MISO Grid-Forming Battery Energy Storage Capabilities, Performance, and Simulation Test Requirements Proposal

DRAFT Whitepaper

July 2024 (Version 0.21)

Figure 2. Unifi IBR Categories

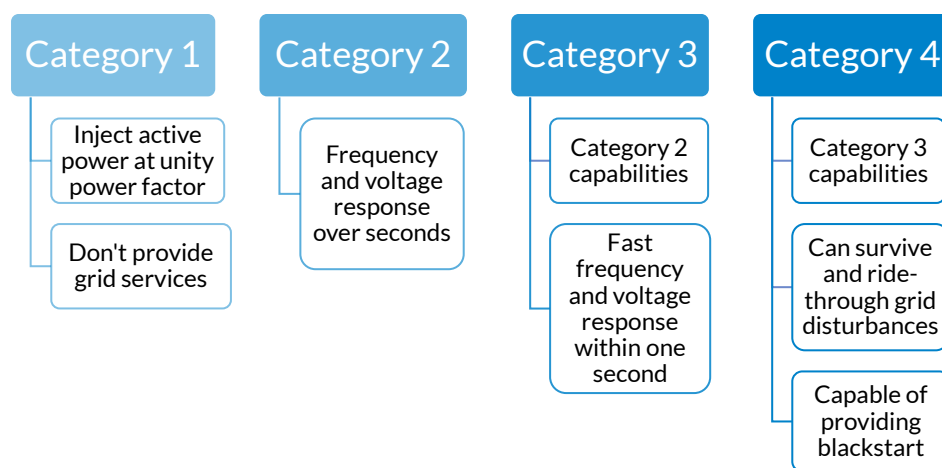
Commented [PD2]: Rev 0.2: change suggested by industry expert review.

"The narrative and the figure can provide an unintended impression that only Category 4 can survive grid disturbances. However, category 3 inverters can also help the system survive large systems.

Further, it is mentioned that category 3 falls under GFL category. Please provide clarifications regarding background for identifying category 3 as GFL. Is it because it may not be able to provide blackstart? If so, suggest to add this note."

Commented [PD1]: Rev 0.2: suggested change from industry expert review

2Figure 2).¹ MISO sees value in this distinction and plans on exploring advanced GFL IBR performance (e.g. unifi Category 3) in a future phase of IEEE 2800-2022 adoption, with plans to assess benefits and risks of inverter-level fast frequency response and voltage controls. However, for the purposes of MISO's GFM IBR adoption, only IBRs that are capable of surviving grid disturbances are in scope (i.e., unifi Category 4). namely the loss of last synchronous machine. While Category 3 IBR can significantly contribute to dynamic stability support, this technology still relies on a grid voltage source.

Figure 8. Test set-up A configured for 100 MW GFM IBR (source: NERC)

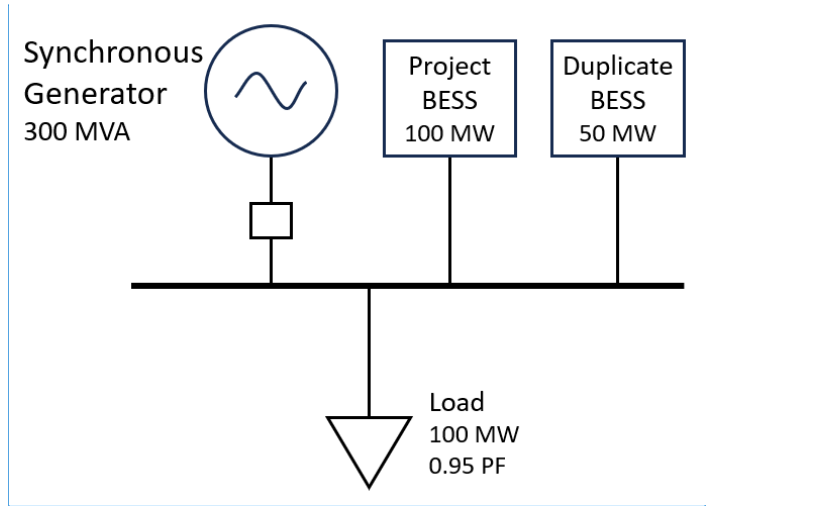
Commented [PD7]: Rev 0.2: Image replaced to remove references to modeling generator excitor and governor.

PHASE JUMP TEST

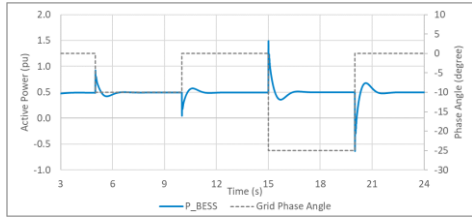
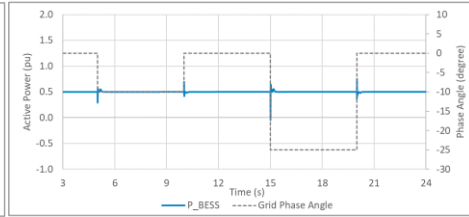
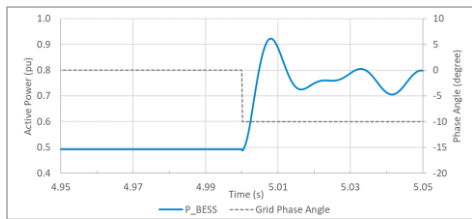
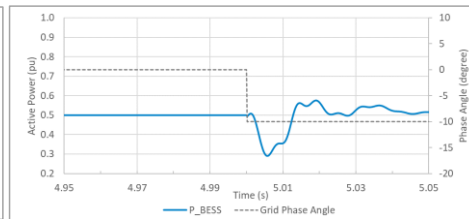
AES reiterates its prior comments that a 60-degree phase change is outside the realm of likelihood, and far beyond the IEEE 2800 requirements. AES request MISO provide further justification on why it believes a test of a 60-degree phase jump is warranted. AES believes that stopping the test at 30 degrees would provide results of more realistic grid conditions that might be observed in operations and is in compliance with IEEE 2800.

⁴⁸ A +/- 60 degree phase angle change is extreme and not anticipated to be a condition within the MISO region in the near-term or mid-term time horizons. The success criteria focuses on smaller phase angle changes, with criteria also accounting for potentially high impedance between POI and inverter terminals.

⁴⁹ The 90% minimum threshold is applied to the minimum active power change of 0.2 pu on the rated active power base. Further, the active power should not reduce below the power output prior to the 10 degree angle jump for at least 50 milliseconds.

LLSM - Discharging Case

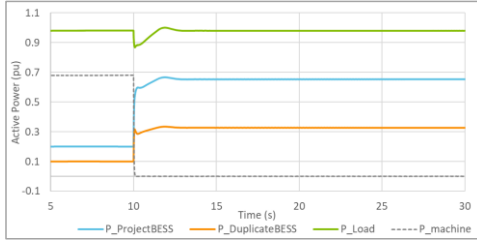
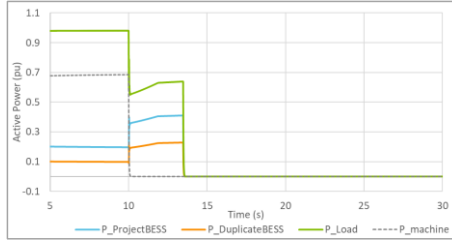
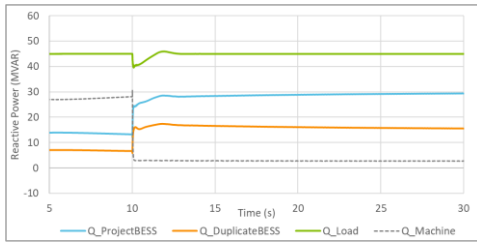
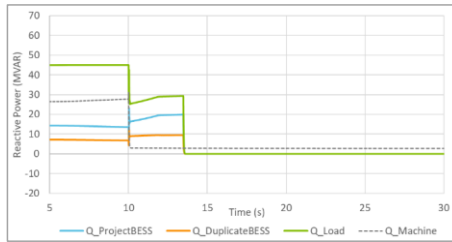
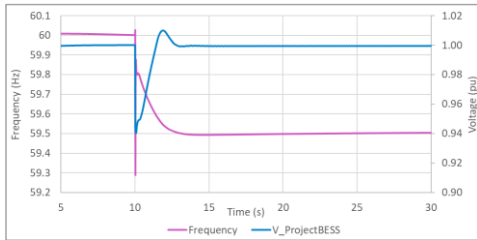
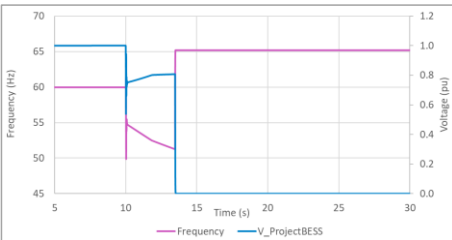
Commented [PD19]: Rev 0.2: Test results for the previous LLSM Case 1, which is no longer included, are shown here for reference. MISO views this case as covered by other cases.

Commented [PD11]: Rev 0.2: previous Case 1 removed because response is covered by other cases. For instance, old Case 4 (new Case 3) is similar and more severe.
